REPORT TO: Mayor James M. Diodati
and Members of Municipal Council

SUBMITTED BY: Planning, Building & Development

SUBJECT: **PBD-2018-32**
AM-2017-011, Official Plan & Zoning By-law Amendment Application
5471, 5491 and 5507 River Road, 4399, 4407, 4413 and
4427 John Street and Part of River Lane
Proposal: Apartment Building Consisting of Two Towers
Applicant: 5507 River Development Inc. (Mike Wang)
Agents: Italia Gilberti, Broderick and Partners
Ryan Guetter, Weston Consulting

cross-sections provided by the applicant. These lines are depicted in red on the following illustrations:

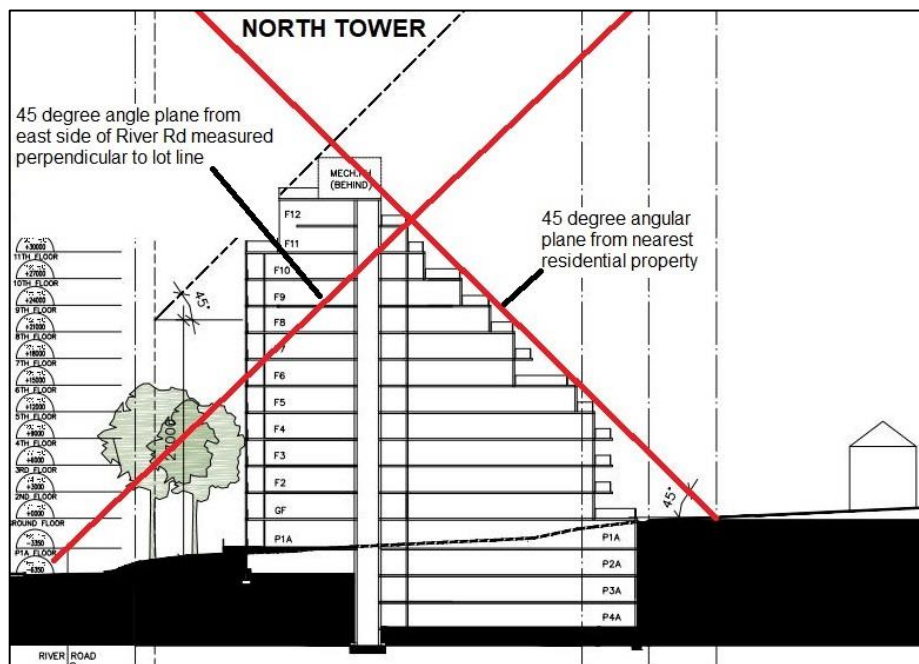
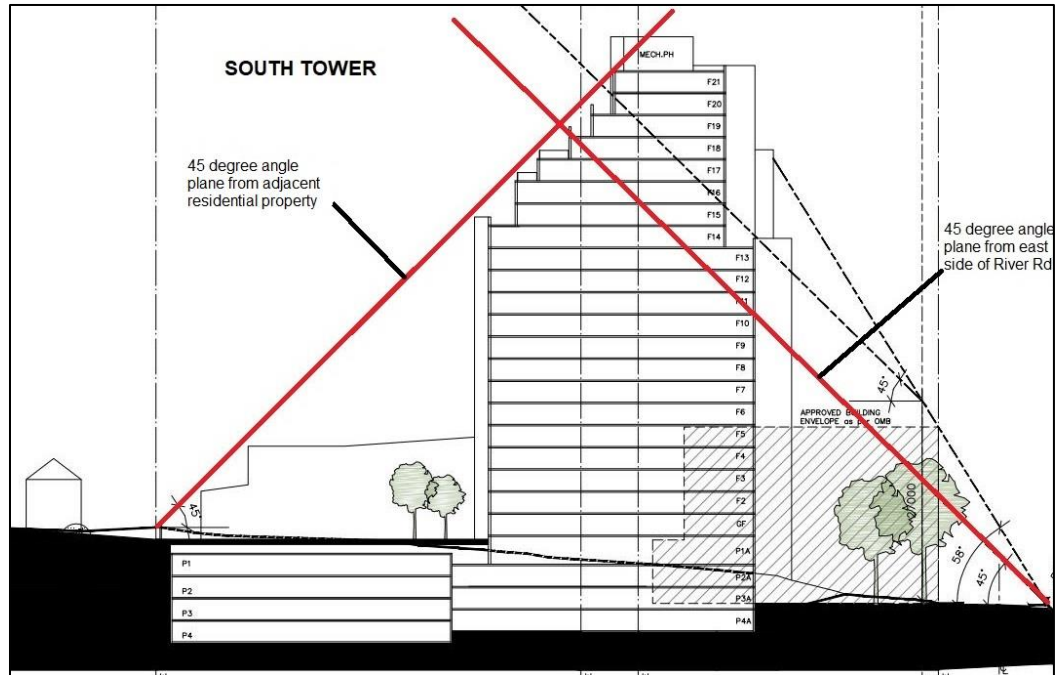
Although the applicant's Planning Consultant cites the NDUG standards and used them to establish a stepped back form from residential properties to the west and from Philip Street, the same angular plane was not used from the east side along River Road. Staff applied the 45 degree angled plane to the building

The intersection of the 45 degree angular plane from the property line of the nearest residential properties with the angular plane from the east side of River

Road provides the maximum height the two proposed towers should be allowed to achieve. Following this principle the south tower would reach a height somewhere in the 10 to 17 storey range while the north tower could achieve a height between 6 and 10 storeys. The stepping down in height along Phillip Street provides a better transition to the low rise built form that prevails on the River Road neighbourhood.

1. That Council defer the Official Plan and Zoning By-law amendment application to enable the applicant time to modify the project in keeping with the following principles:
 - a. The towers being stepped back in accordance with a 45 degree angular plane measured from the east side of River Road, as detailed in this report;
 - b. A minimum 6 metre exterior side yard building setback being provided from River Road;
 - c. A 3 metre wide landscaped open space strip being provided between John Street and any parking area; and
 - d. Maintenance of the separation distance between the two towers and the setbacks and stepped back form from John and Phillip Streets and the residential properties to the west as shown in the schedules to this report.
2. The public meeting be continued once revised drawings implementing the above noted recommendations have been received and reviewed by Staff.
